weekly notice

Monday, 14 August 2017
Sunday, 20 August 2017

*GENERAL MANAGER SAFETY AND STANDARDS
SYDNEY TRAINS*

HORNSBY JUNCTION REMODELLING PROJECT STAGE 23
SIGNALLING ARRANGEMENT DIAGRAM
PART 1 OF 3

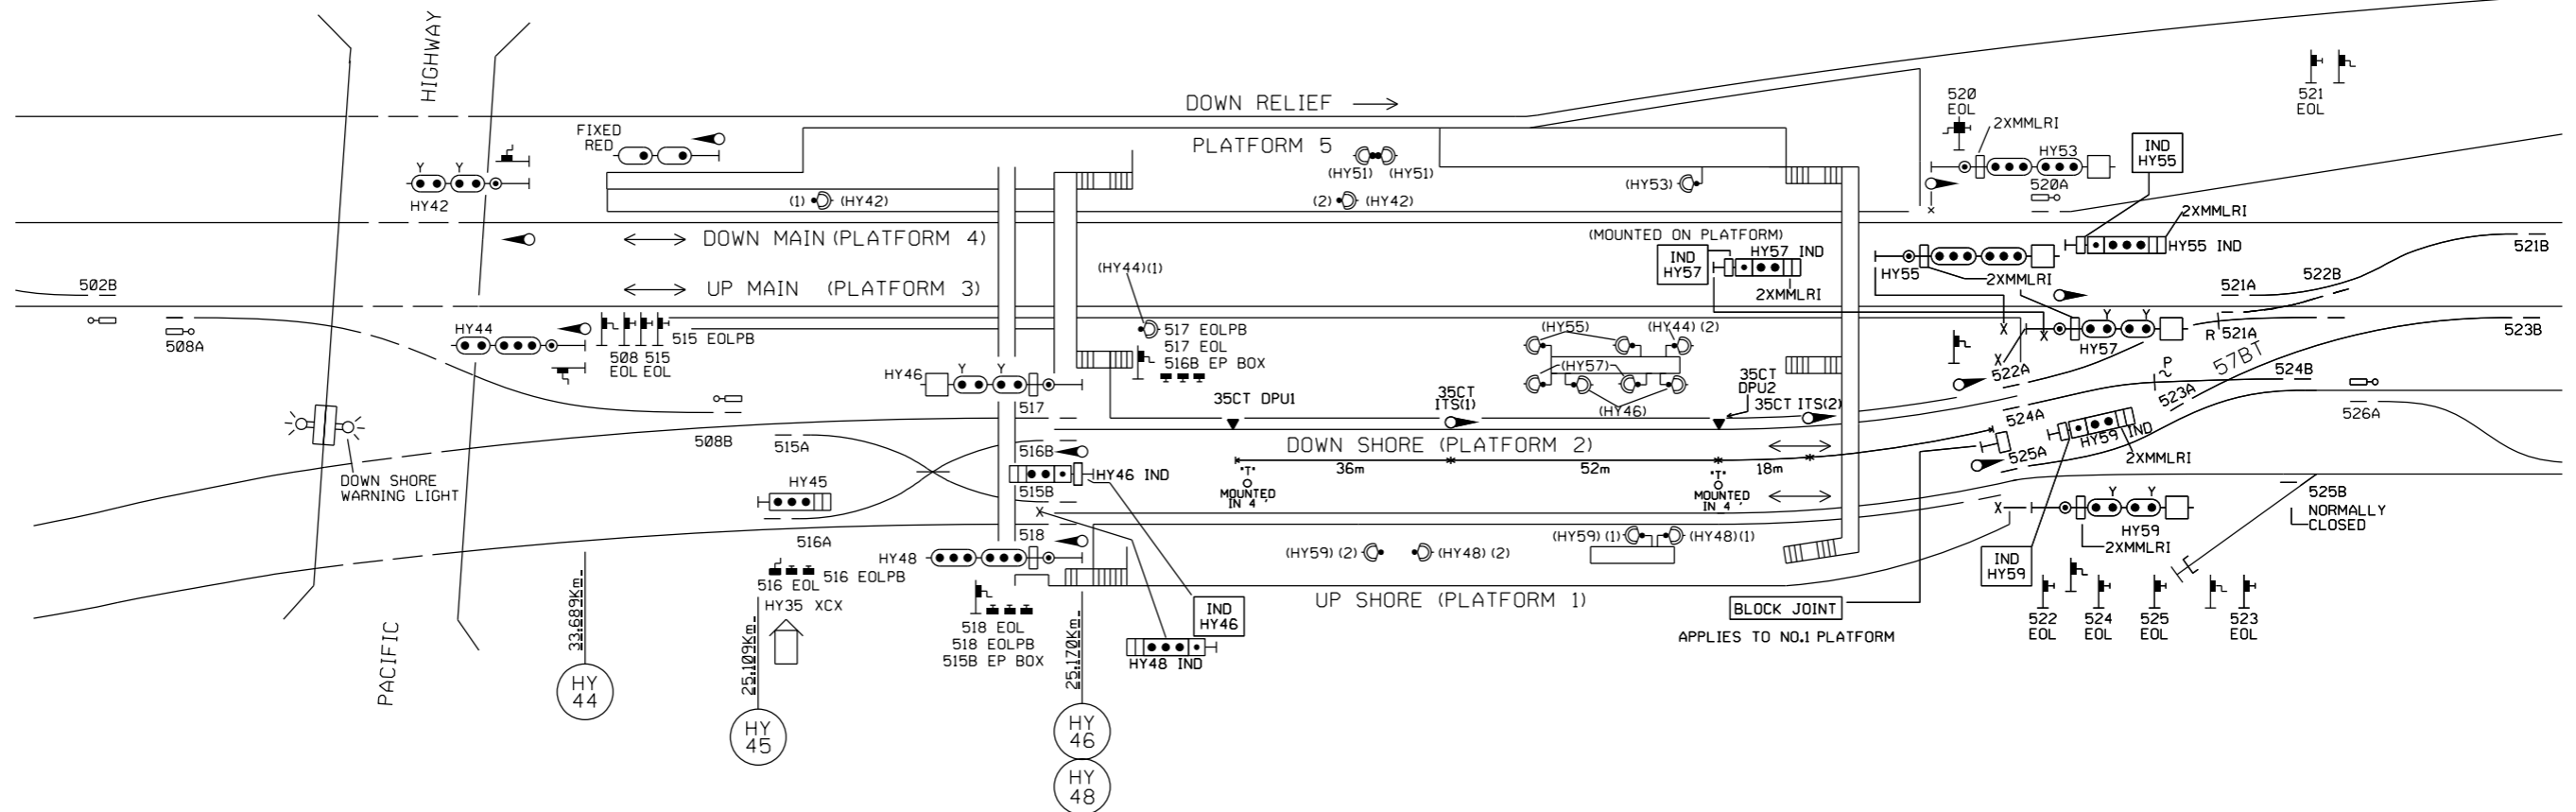
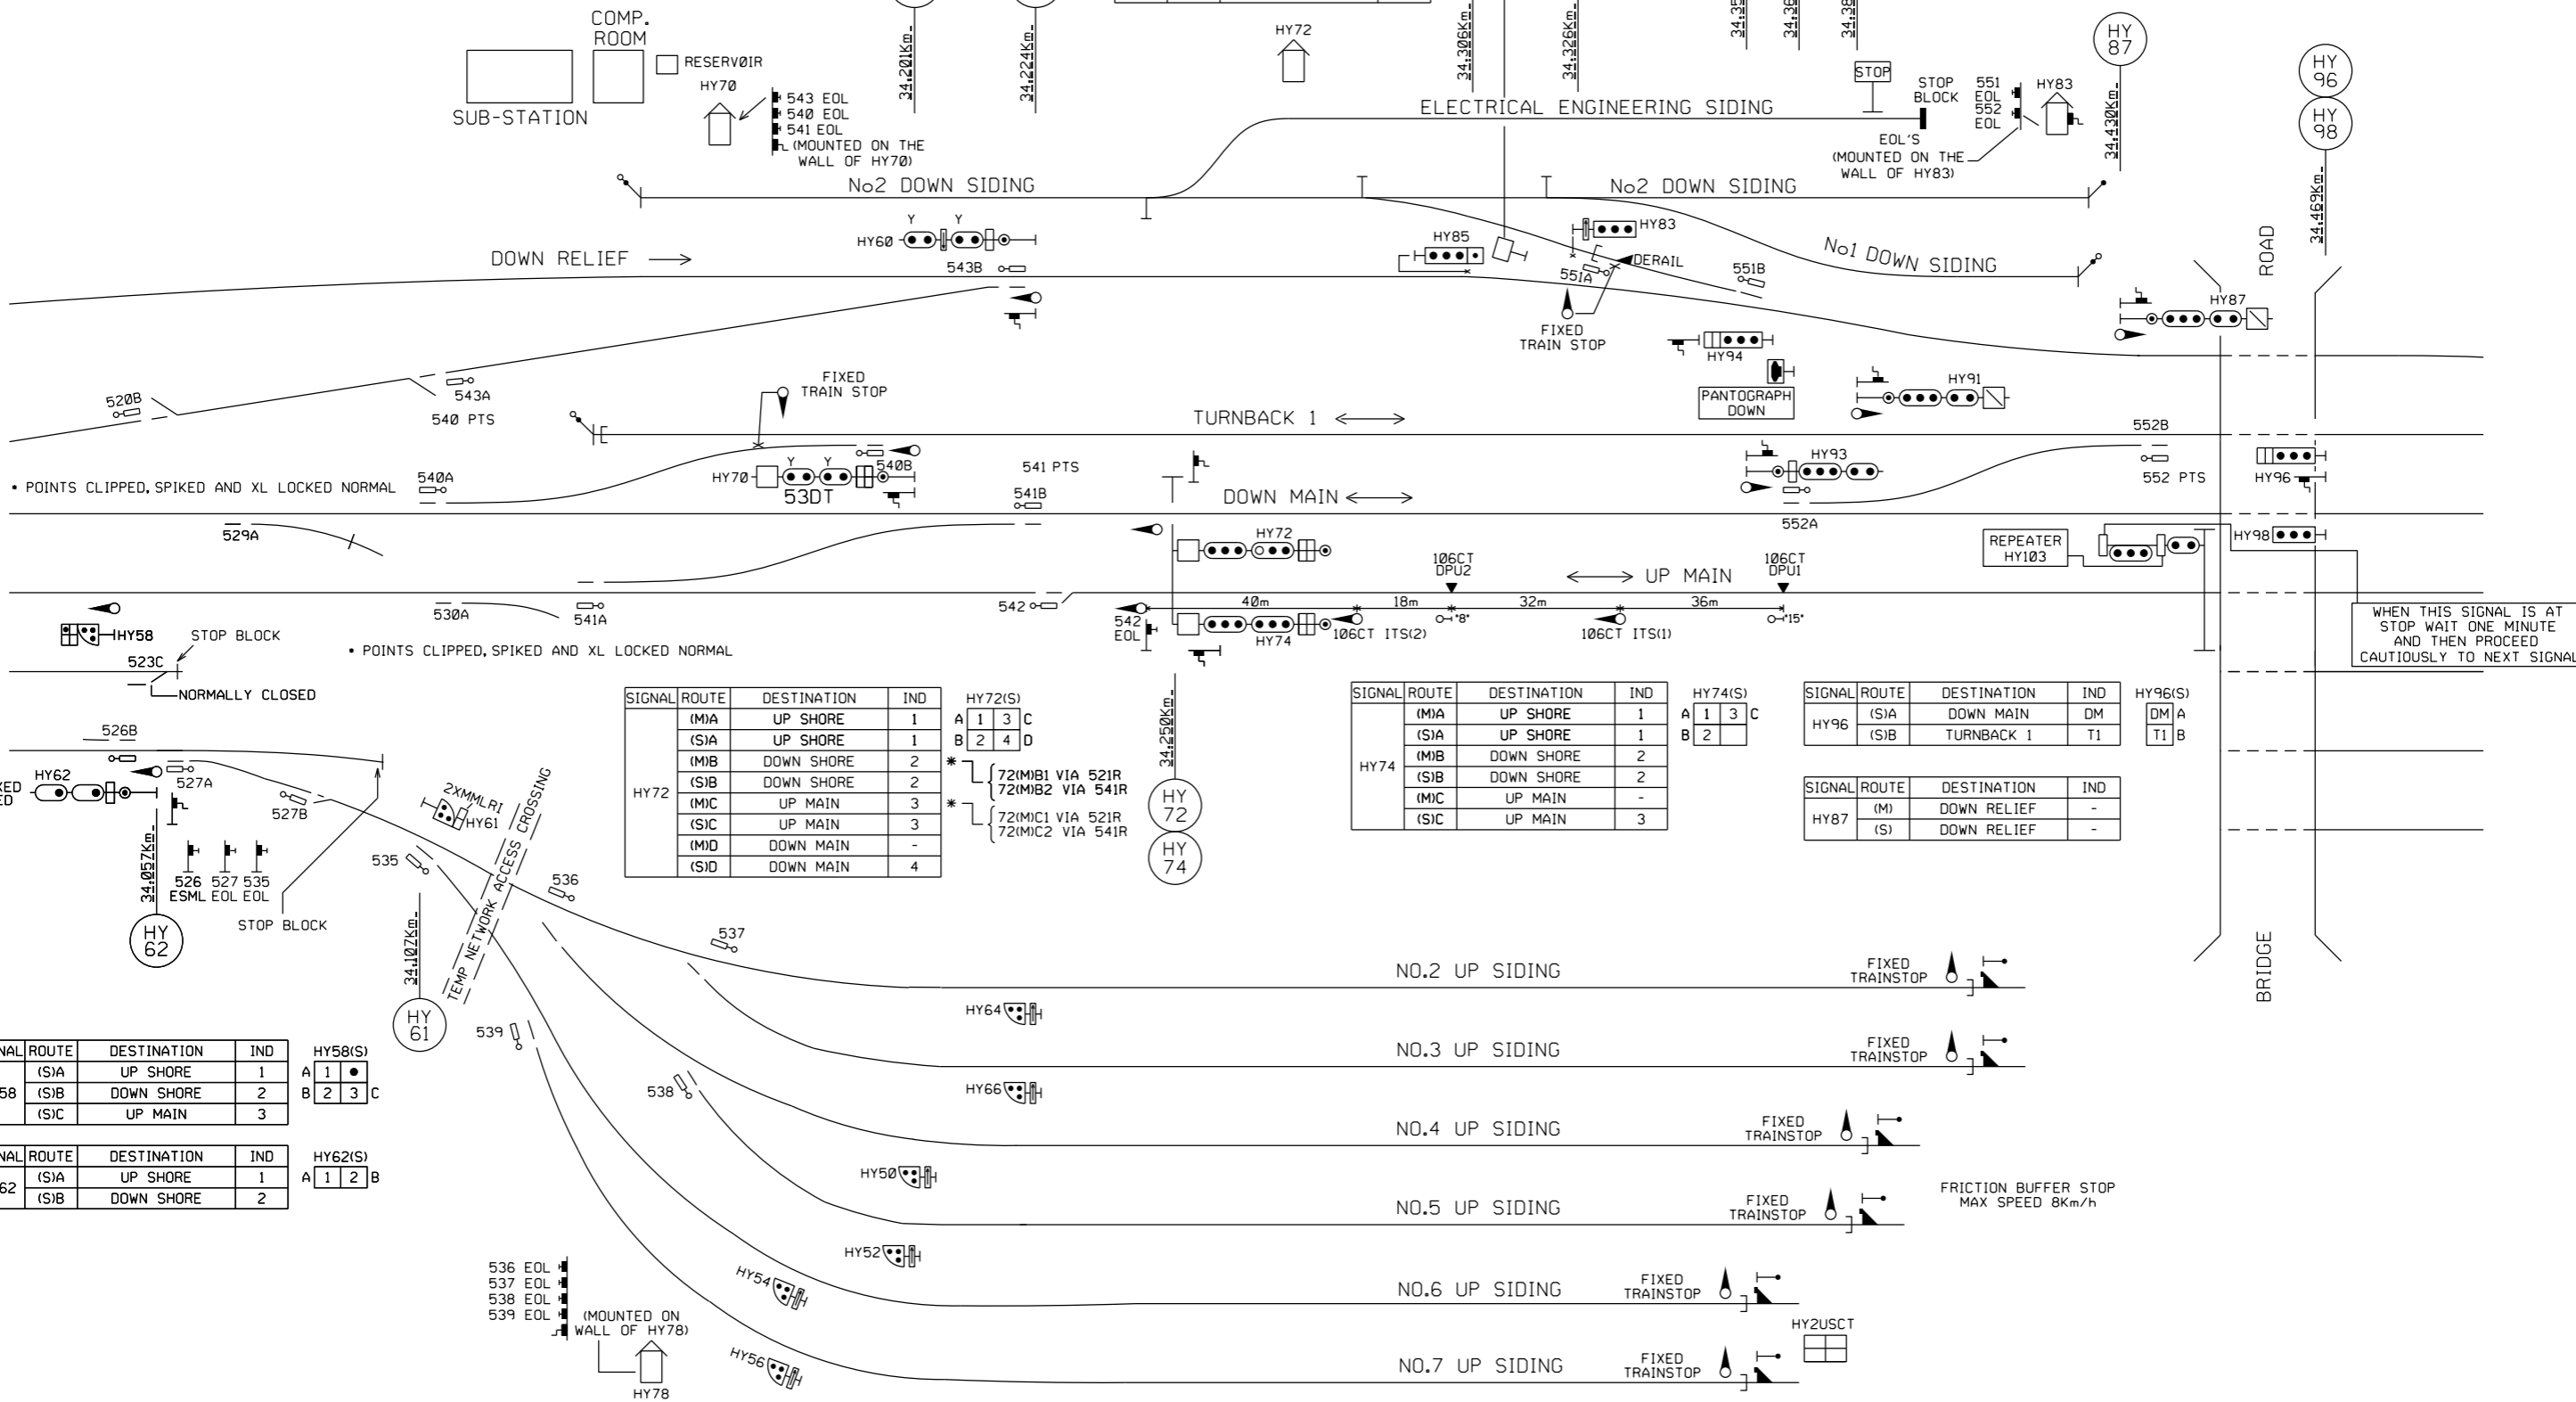
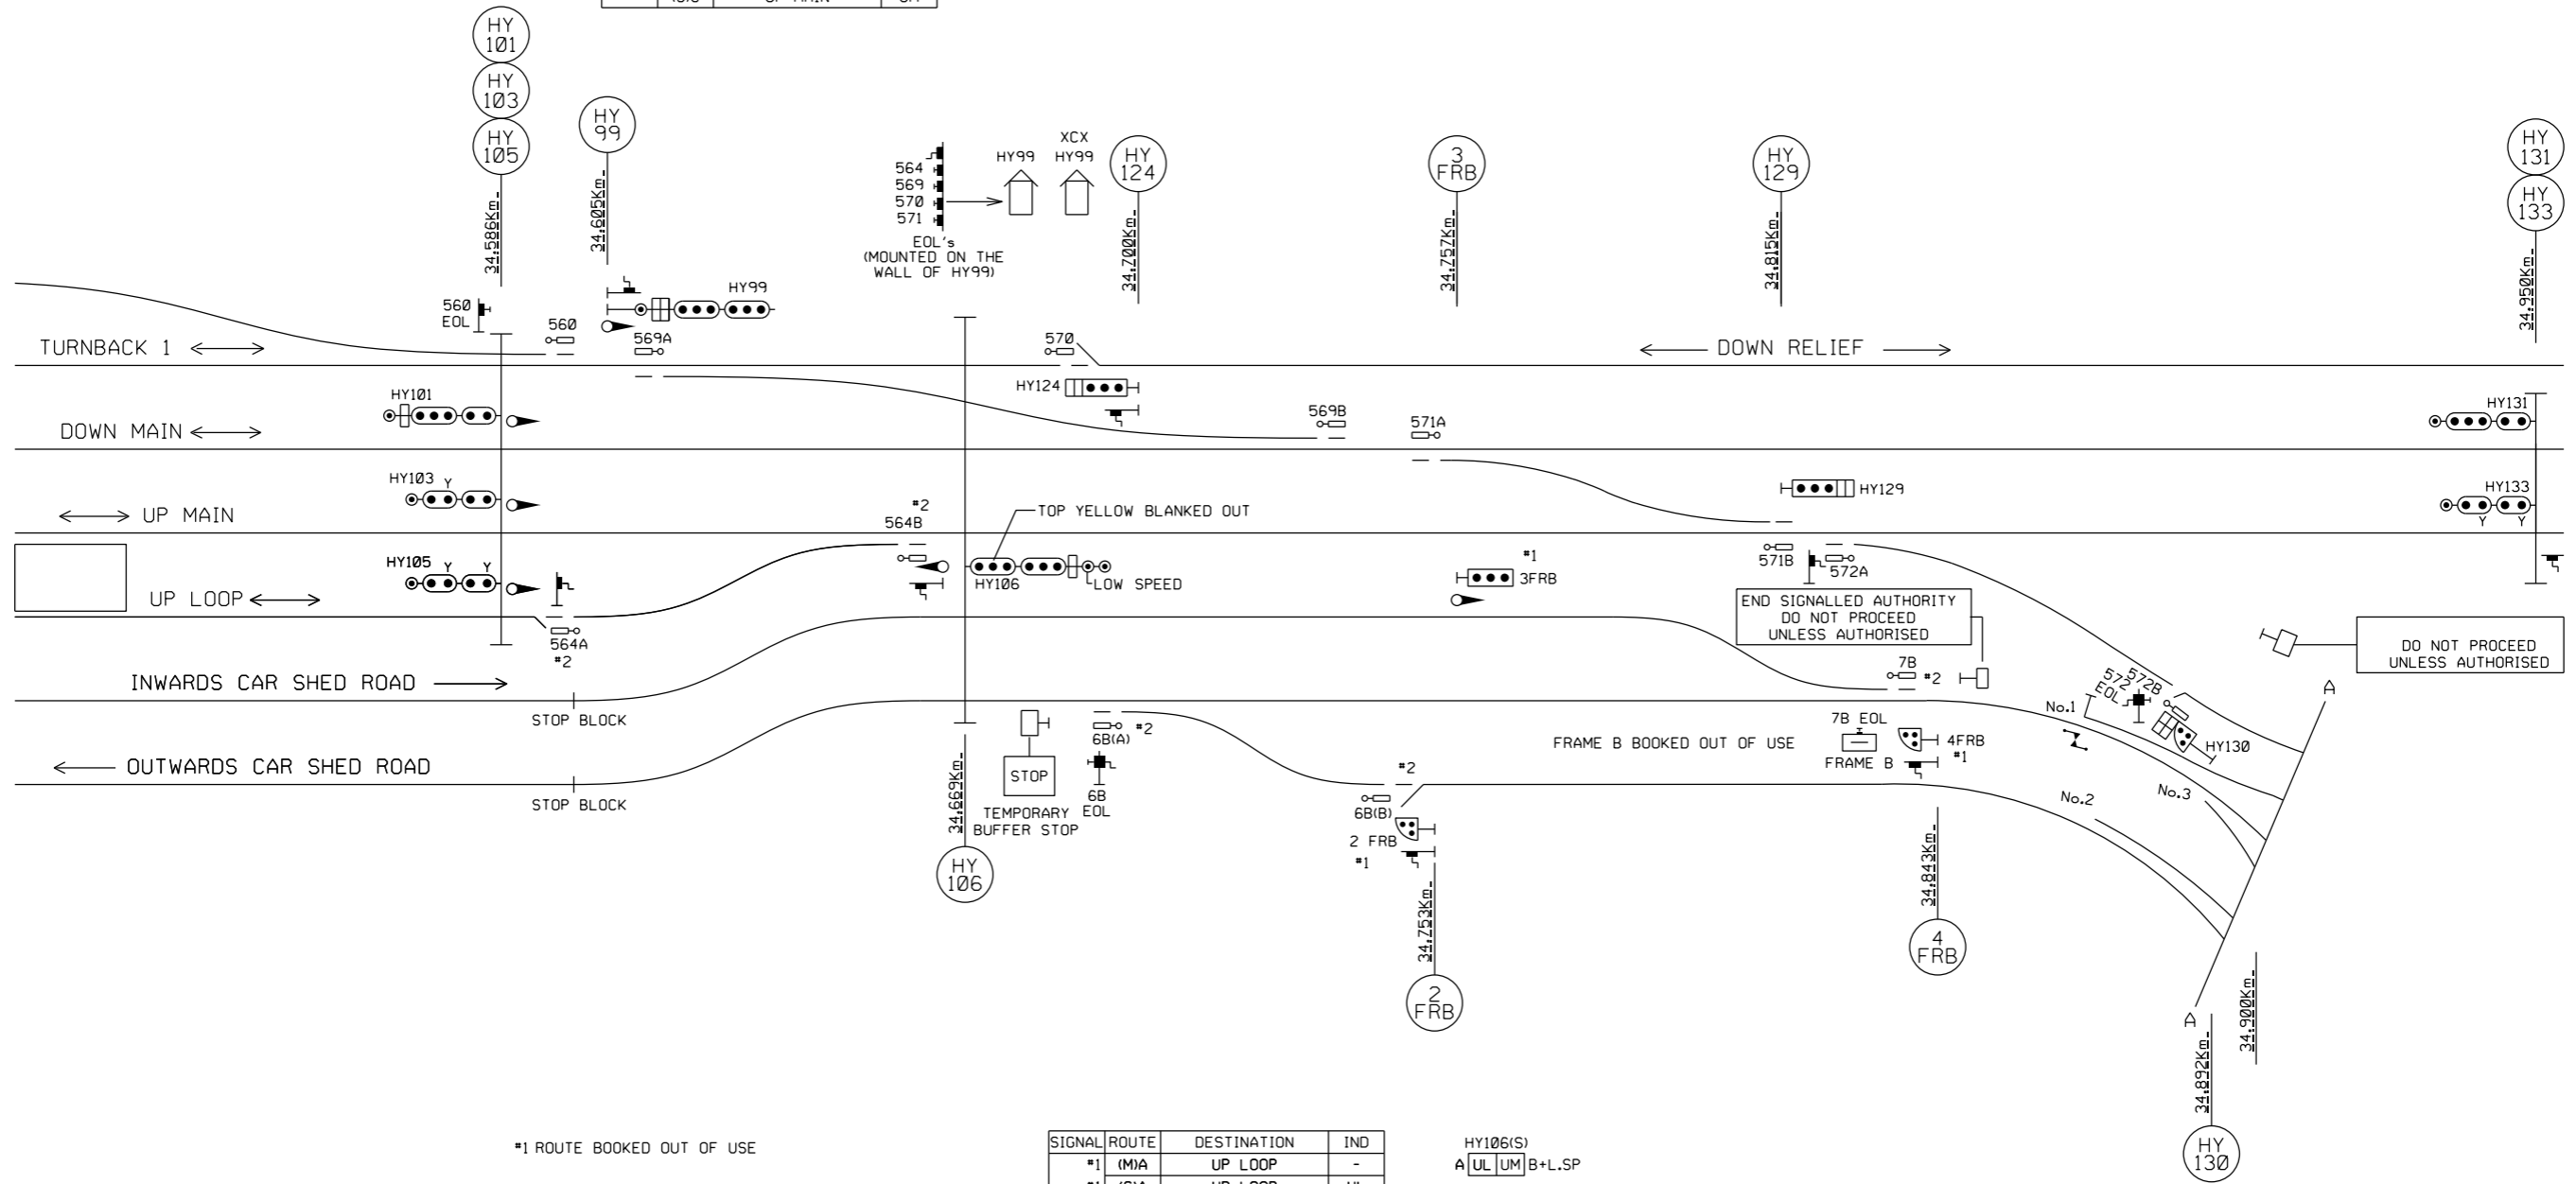
HORNSBY – YARD AREA BOOK-OUT AND REMOVAL

- Hornsby Yard area will be booked out of use and progressively removed.
- A temporary network access crossing will be installed at the entry of No.2-7 Up Sidings at approximately 34.126km

The Hornsby yard area will be booked out of use and progressively removed over a 4 month period in preparation for the final configuration.

All train movements between the Main Lines and the Up Loop, No.1 Up Siding, Inwards Car Shed Road and the Outward Car Shed Road will be disabled.

A single entry to the Hornsby Car Siding from the Main Lines will be available via 572 Points.

Frame B will be booked out of use. Local shunting will enable train movements between the Car Siding and the country end of the Outward Car Shed Road. A new temporary buffer stop will be provided to represent the limit of train movements towards the city.

The following points will be Clipped, Spiked and XL Locked Normal.

All vital normal detection for removed points has been retained within the interlocking. These points will have to be re-stroked normal in event of a system reboot or power-down. Reverse detection has been removed.
